**CENTRAL SEWERSHED PACKAGE 14 – CIPP (LD)**  
**Solicitation Number: CO-00524**  
**Job No.: 20-4510**

**ADDENDUM 1**  
**March 4, 2022**

CENTRAL SEVERSHED PACKAGE 14 - CIPP (LD)  
 PAVEMENT PLAN  
 SHEET 4 OF 11

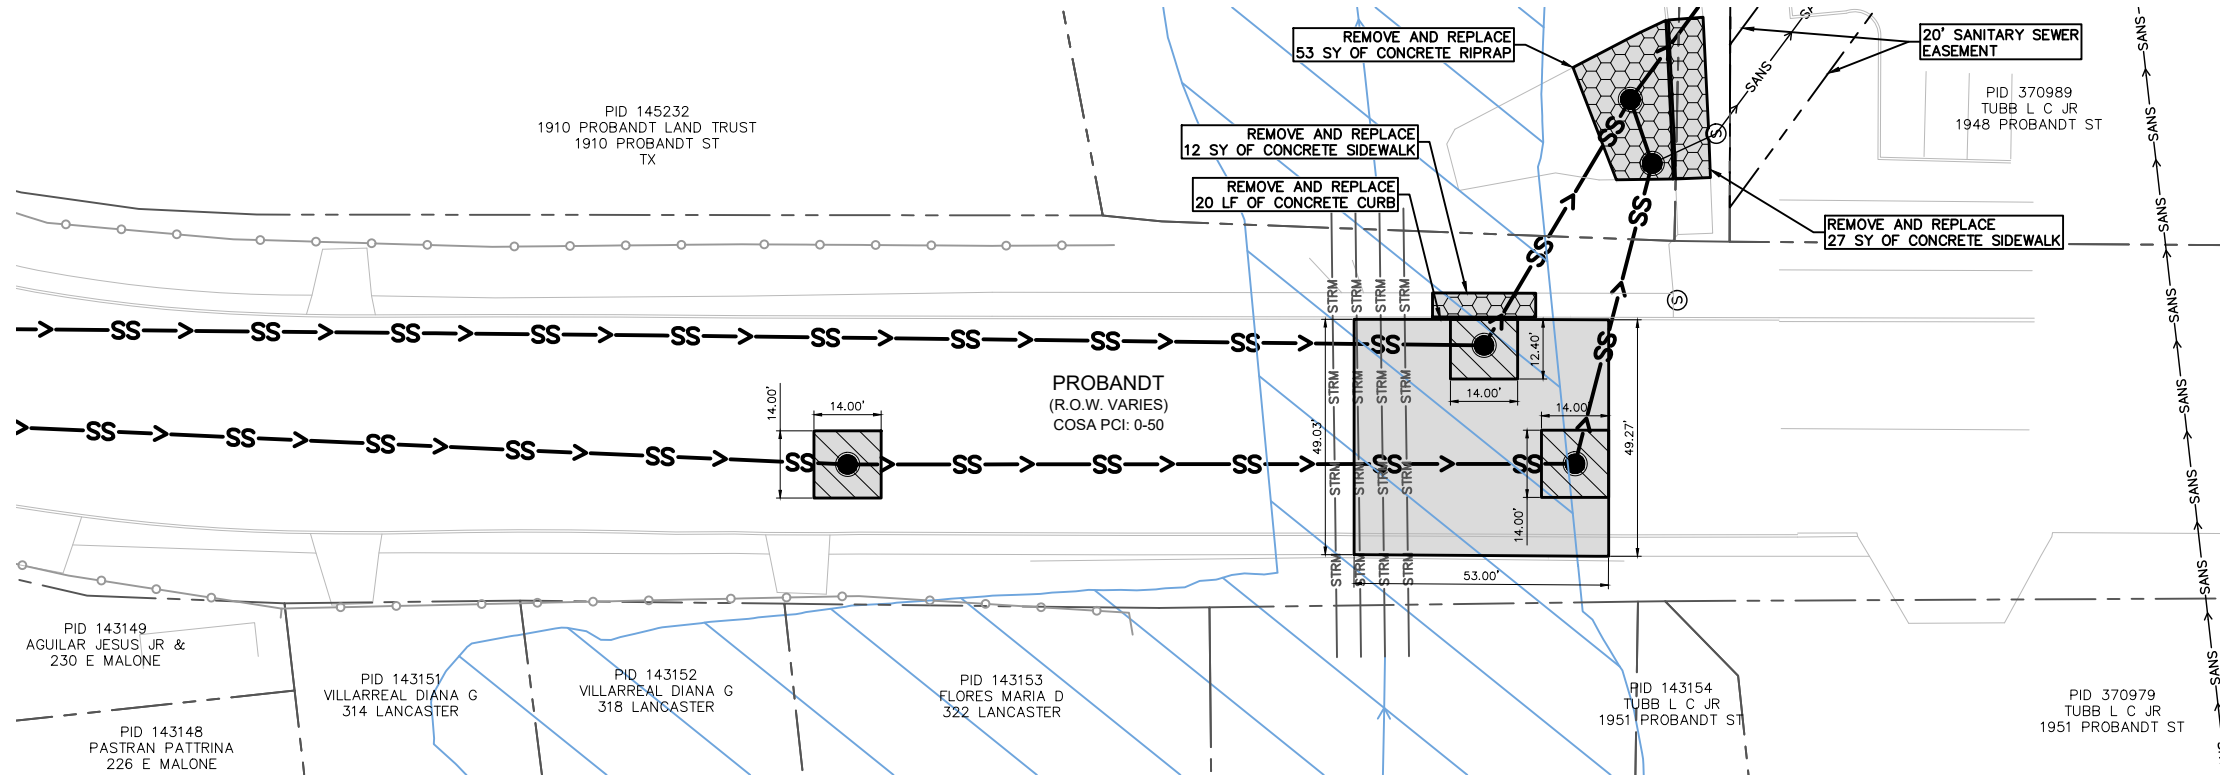
1. Remove the following sheets dated 2/4/2022 and replace with the attached sheets dated 3/3/2022
  - a. Sheet GEN-02 Sheet List and Overall Quantities
  - b. Sheet C-37 Pavement Plan (Sheet 4 of 11)
